Project No. 2022\_110

## Midlothian ISD Baxter ES Kitchen Upgrades

### ADDENDUM NO. 2

March 20, 2023

E100

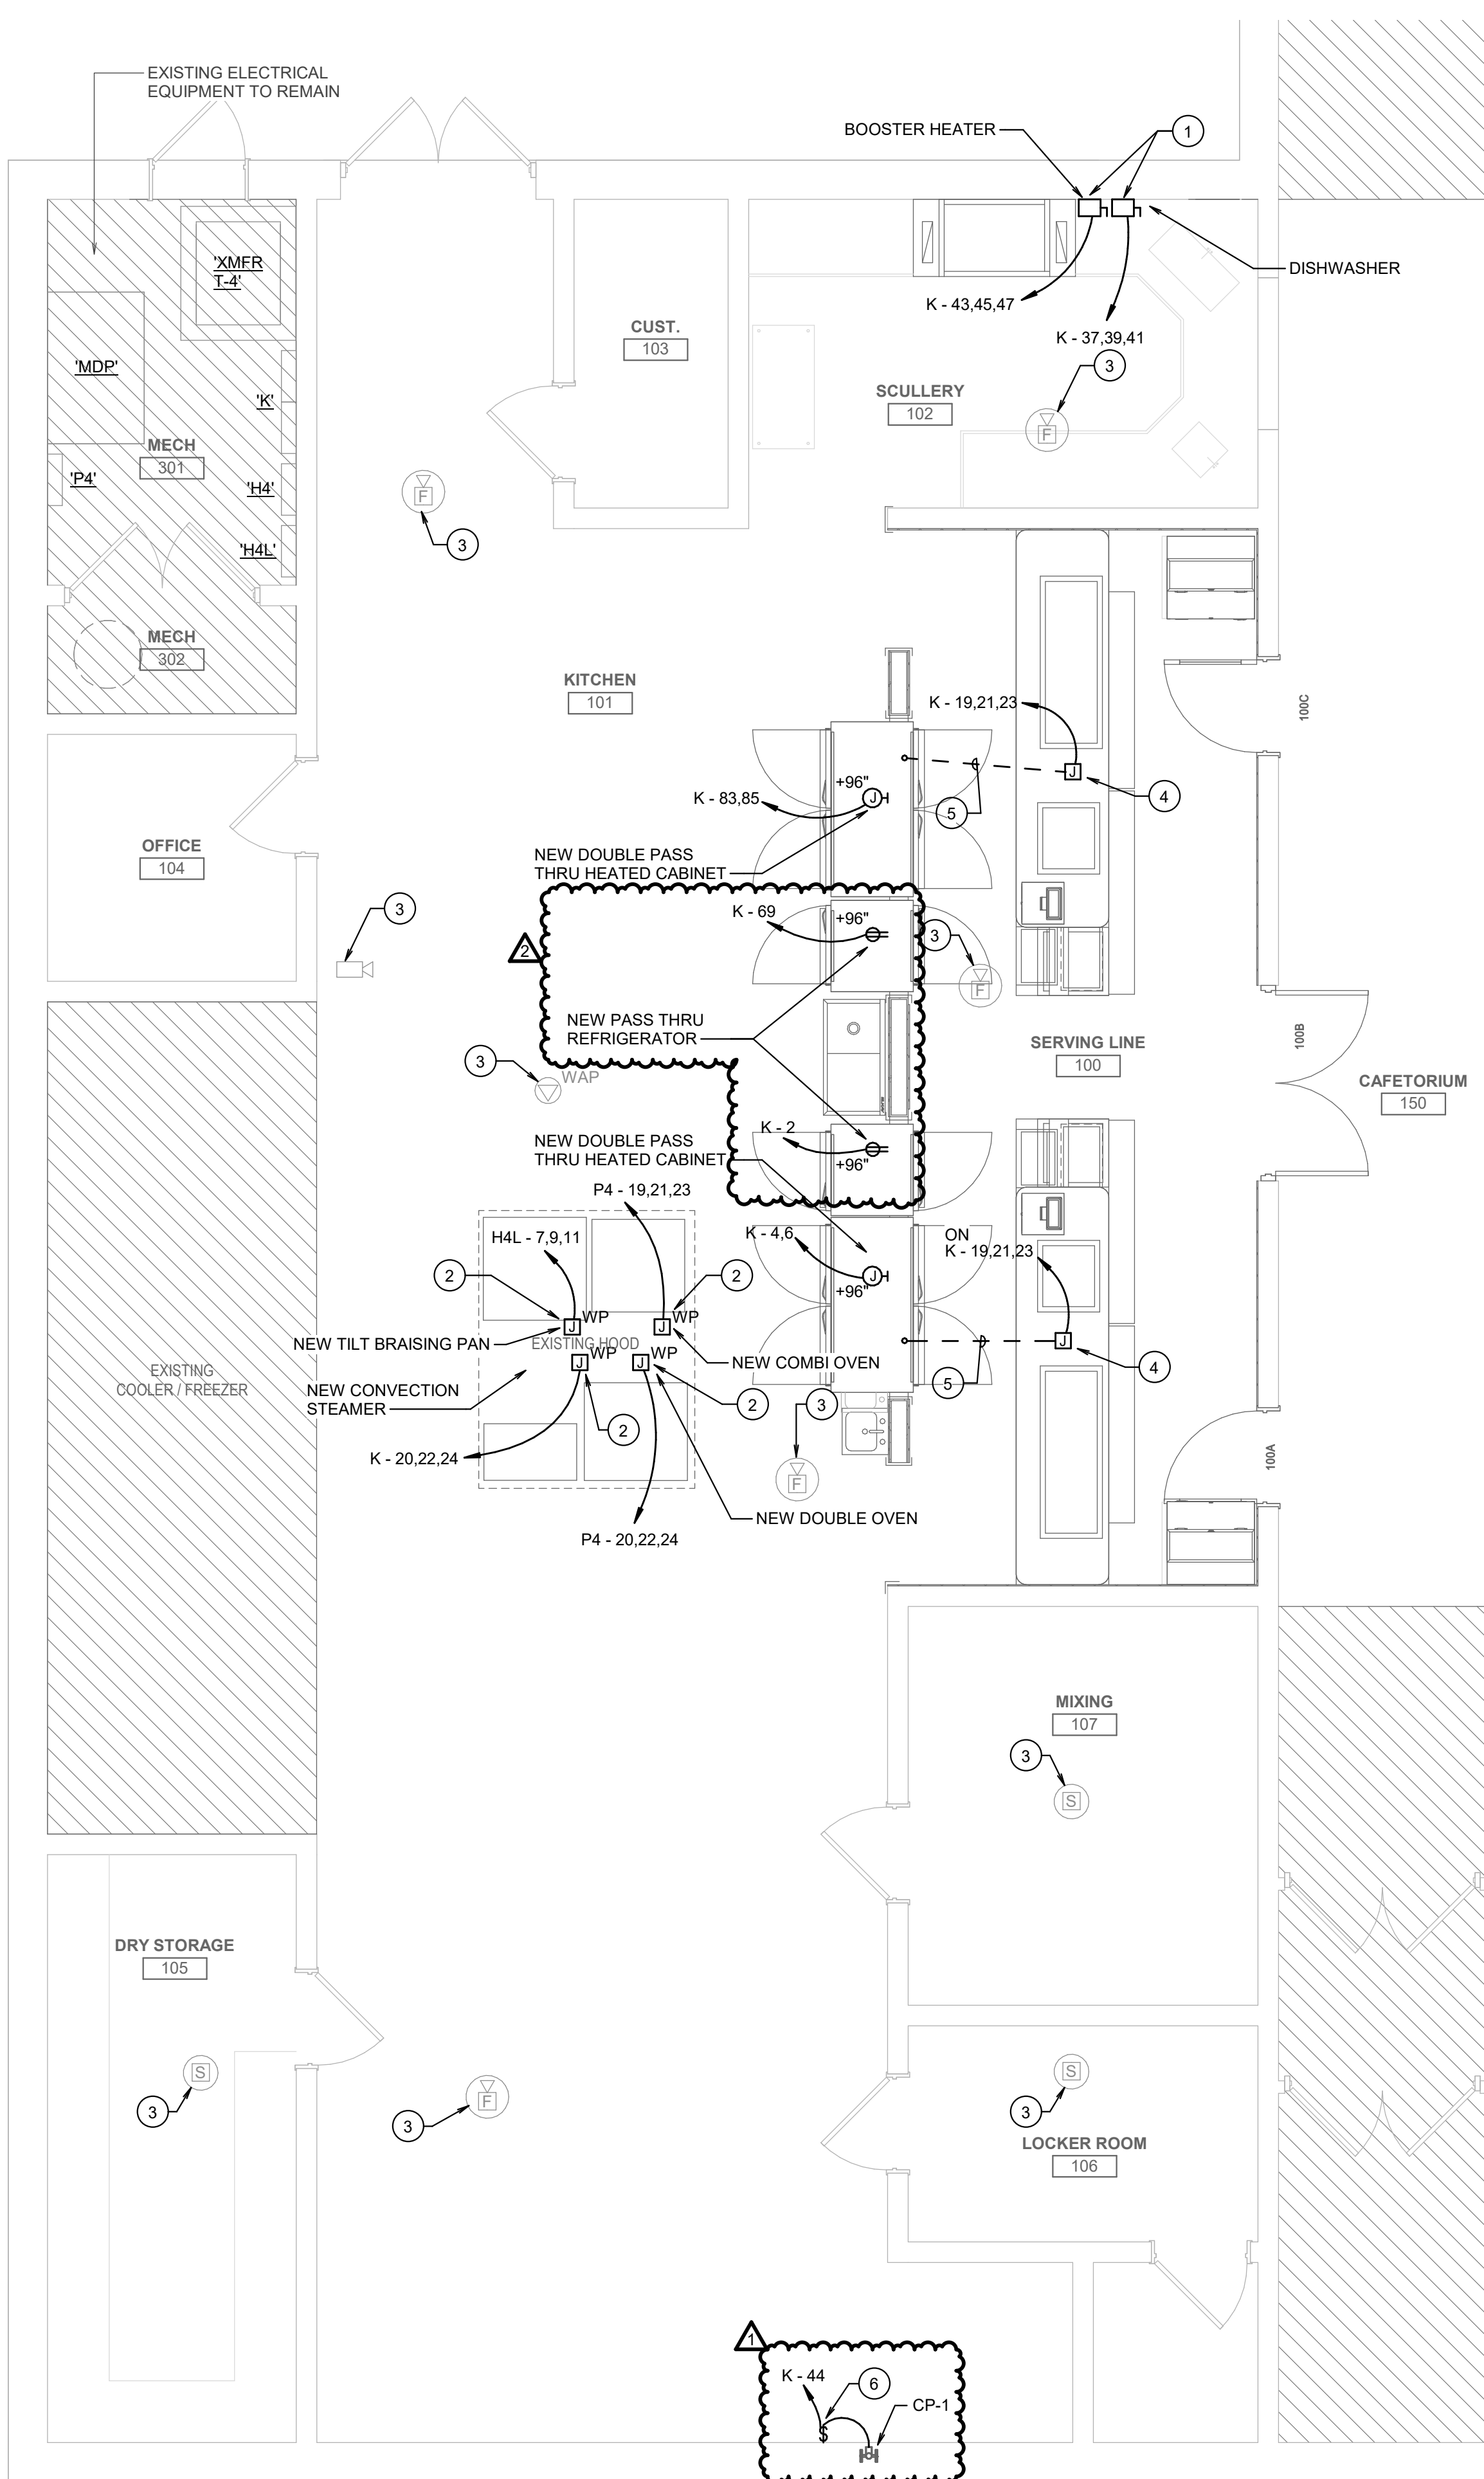
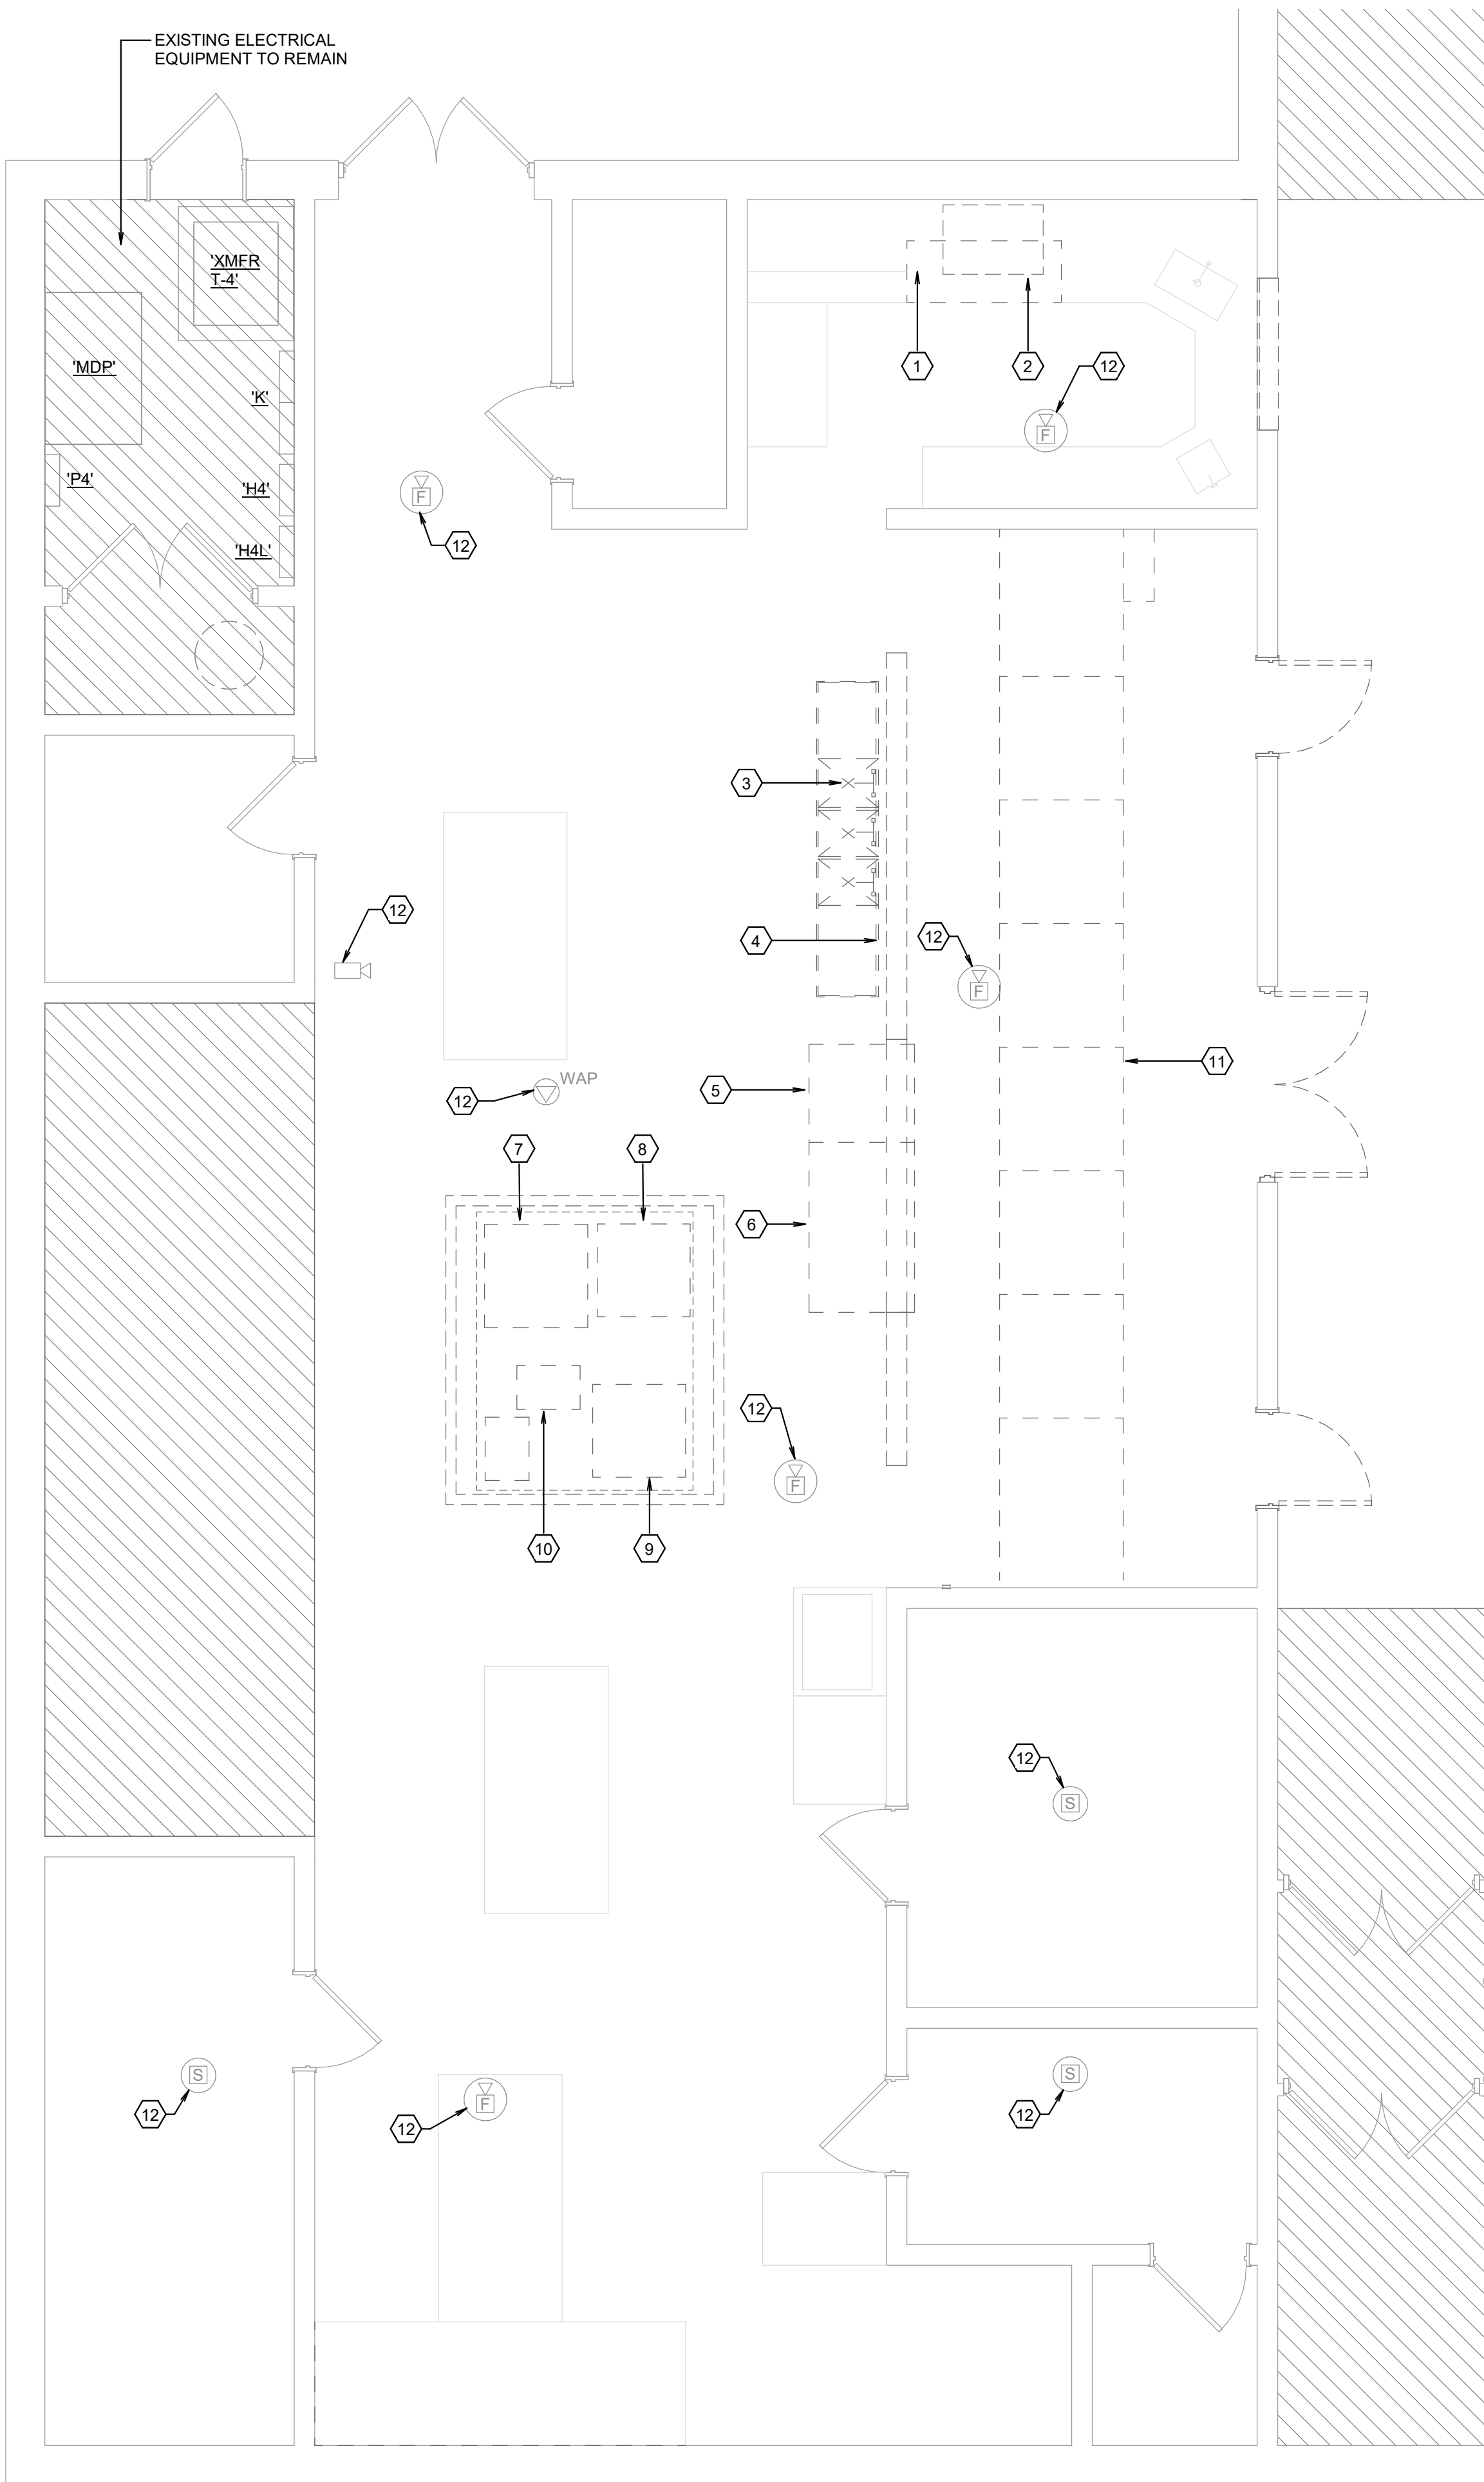
ITEM NO. 03 E100 – FLOOR PLAN – LEVEL 1 - ELECTRICAL

- A. Revised power / receptacle location for new double oven layout.
- B. Added power and switch for booster pump (CP-1) and added keyed note 6 under 'NOTES BY SYMBOL' for the same.
